PROPOSAL REQUEST 127

Transformer Pad Grading

ISSUED: April 21, 2025

PROJECT: AWSOM
BENTONVILLE, AR

Contents:
Materials Plan -
Ground Floor 2/3

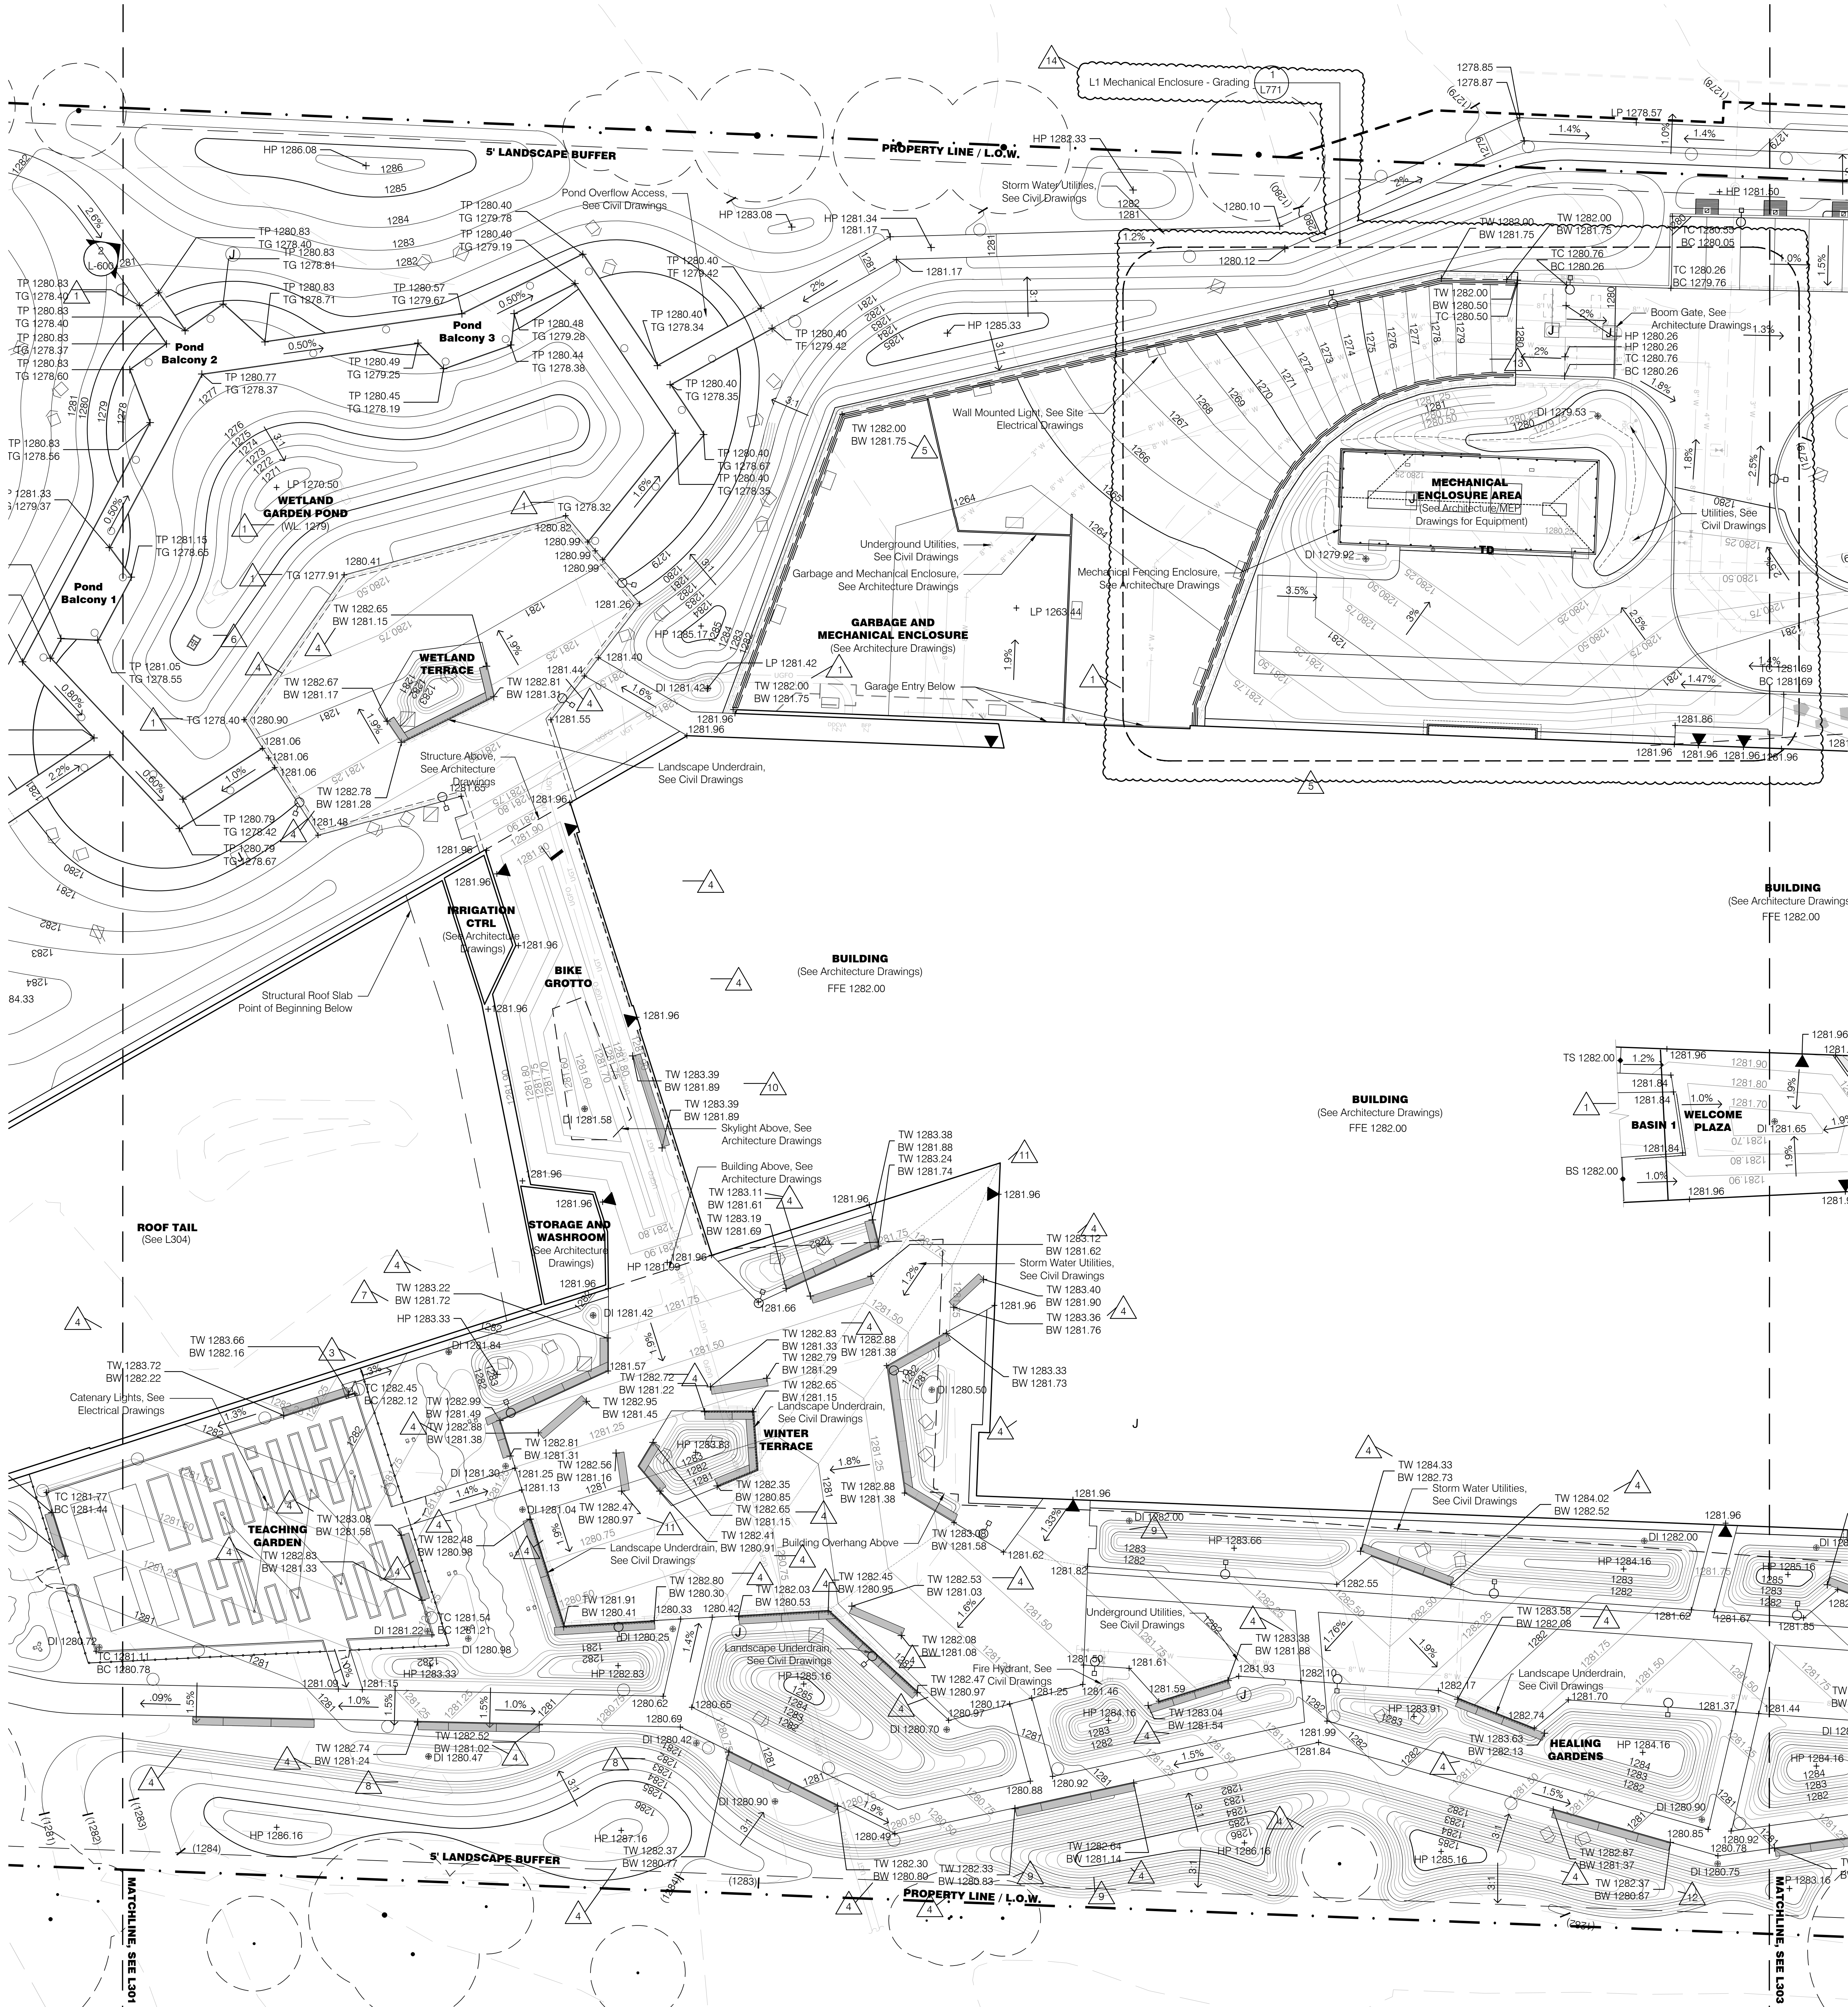
- a) Refer to Revised Sheet **A000B**, with original issue date 10.21.2023 and revised date 04.21.2025.
- Updated sheet issuance for PR 127.
- b) Refer to Revised Sheet **L102**, with original issue date 03.13.2023 and revised date 04.21.2025.
- Added MSE Wall Maintenance Strip.
 - Added (2) landscape boulders.
 - Added 6" wide reinforced CIP Retaining wall.
- c) Refer to Revised Sheet **L302**, with original issue date 03.13.2023 and revised date 04.21.2025.
- Updated grading at the transformer enclosure.
- d) Refer to Revised Sheet **L916**, with original issue date 08.29.2024 and revised date 04.21.2025.

L1 Mechanical
Enclosure - Grading

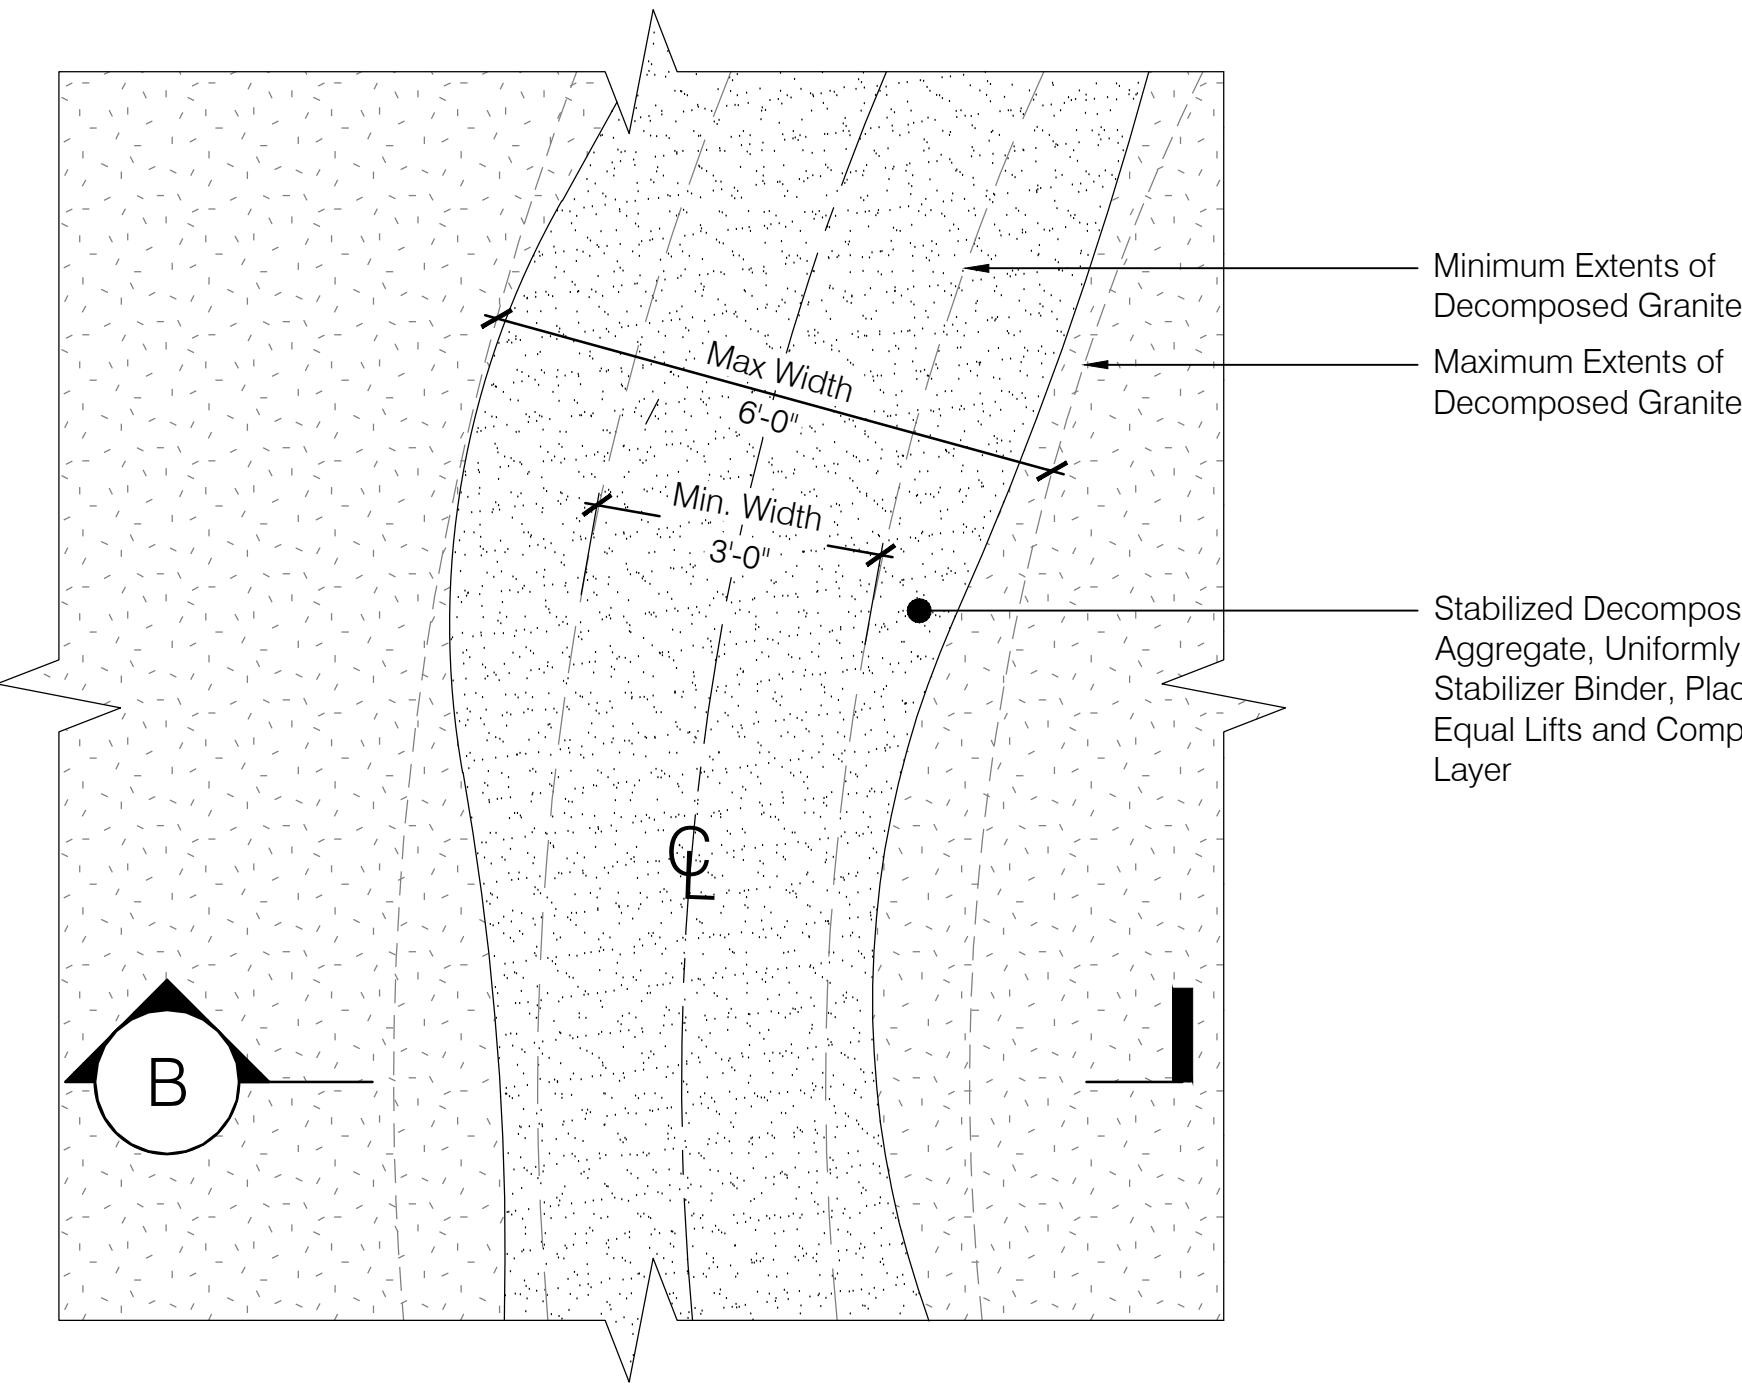
- a) Refer to Revised Sheet **L771**, with original issue date 04.21.2025.
- Added Grading Enlargement for the L1 Mechanical Enclosure.
 - Updated grading surrounding the transformer enclosure.
 - Updated grading of the transformer pad.
 - Added retaining wall on the NW corner of the enclosure.
 - Added (1) area drain and (1) trench drain.
 - Removed (2) area drains.

4 MSE Wall Maintenance Strip
Scale: 1/2" = 1'-0"

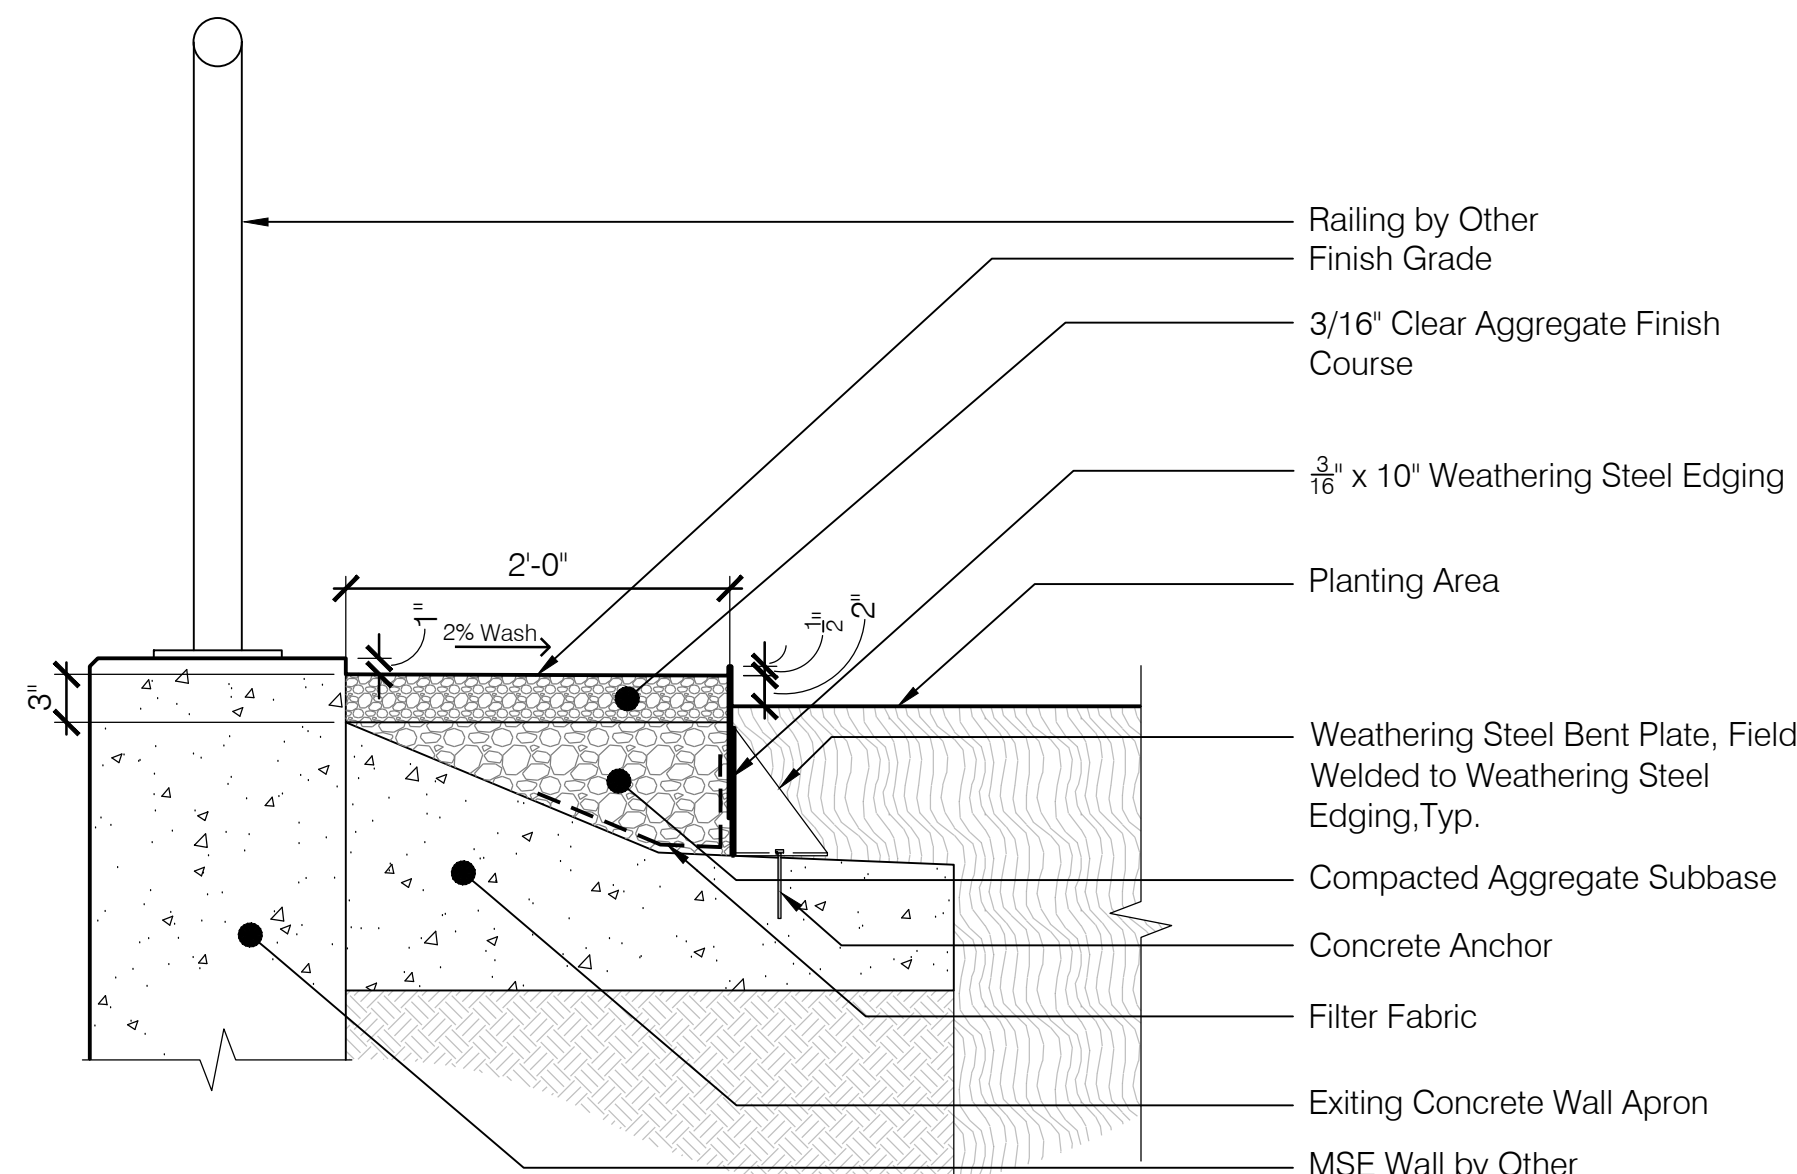
- Added detail 4, MSE Wall Maintenance Strip.
